DUKE POWER COMPANY

OCONEE NUCLEAR STATION, UNIT NO. 1

AMENDMENT TO FACILITY OPERATING LICENSE

ATTACHMENT TO LICENSE AMENDMENTS

ROD POSITION LIMITS
 FOR FOUR PUMP OPERATION
 FROM 150 ± 10 TO 390 ± 10
 EFPD - 30
 UNIT 2
 OCONEE NUCLEAR STATION
 Figure 3.5.2-1B2

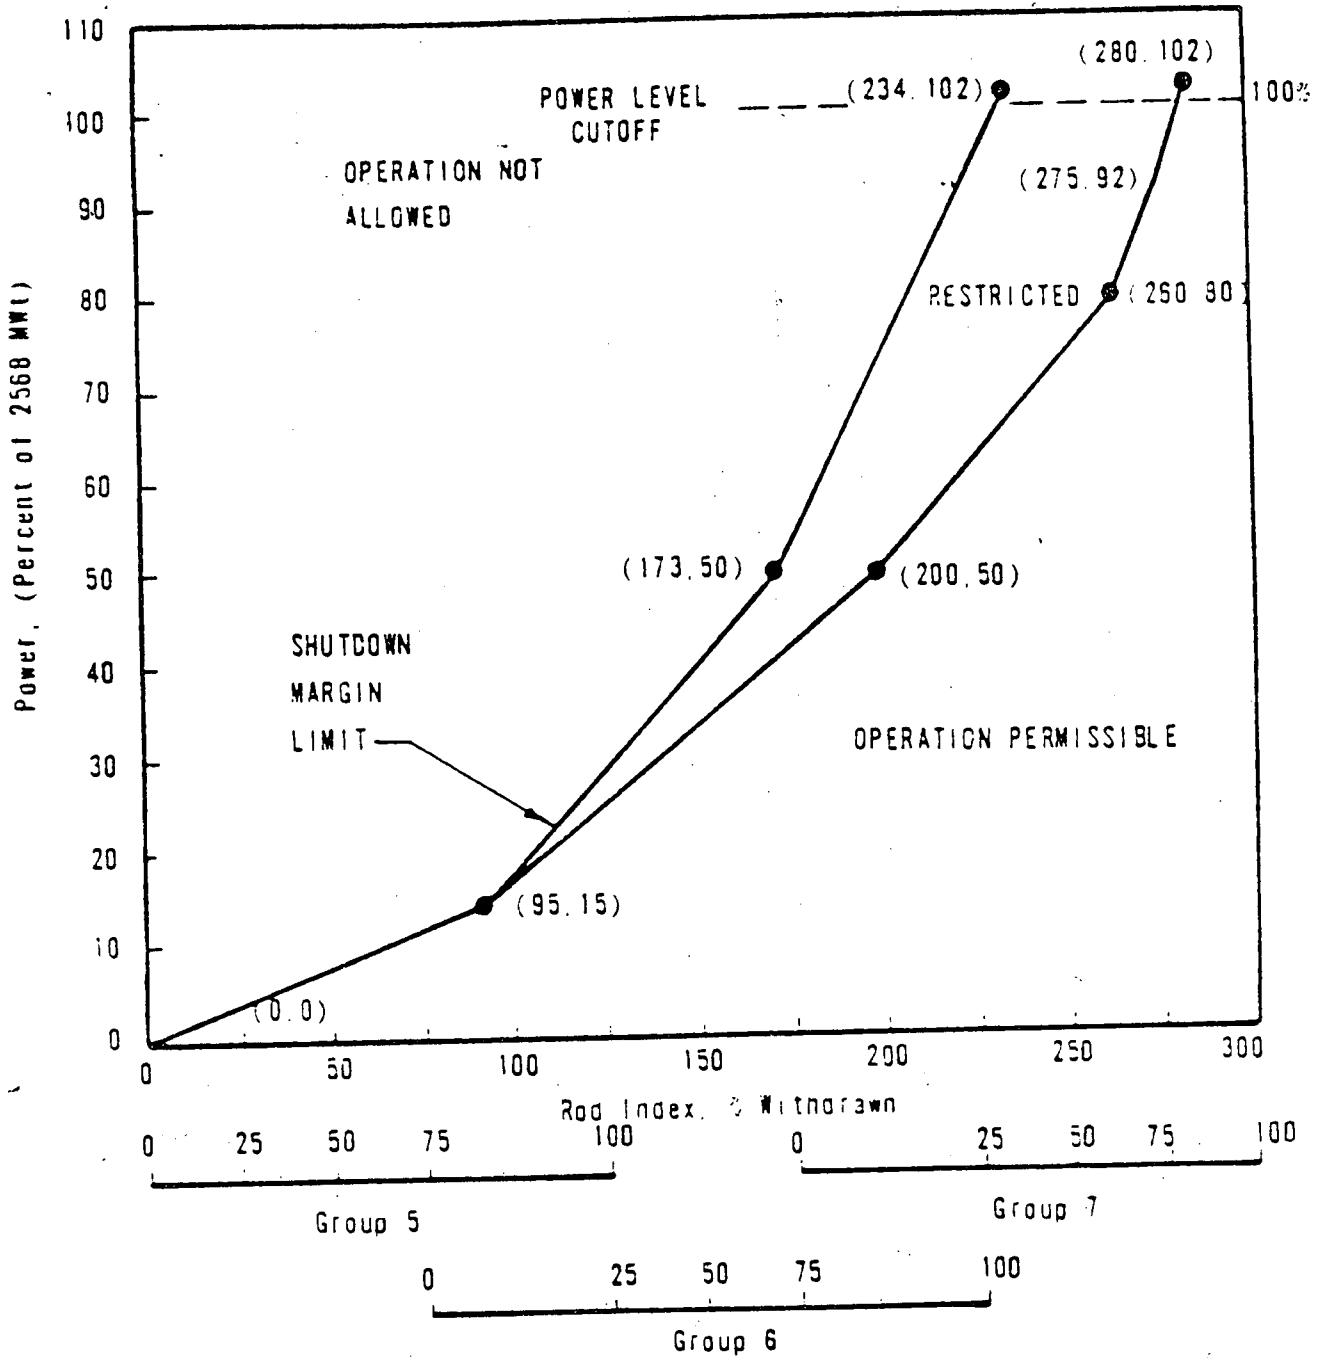
Replace the following pages of the Appendix "A" Technical Specifications with the attached pages. The revised pages are identified by amendment numbers and contain vertical lines indicating the area of change.
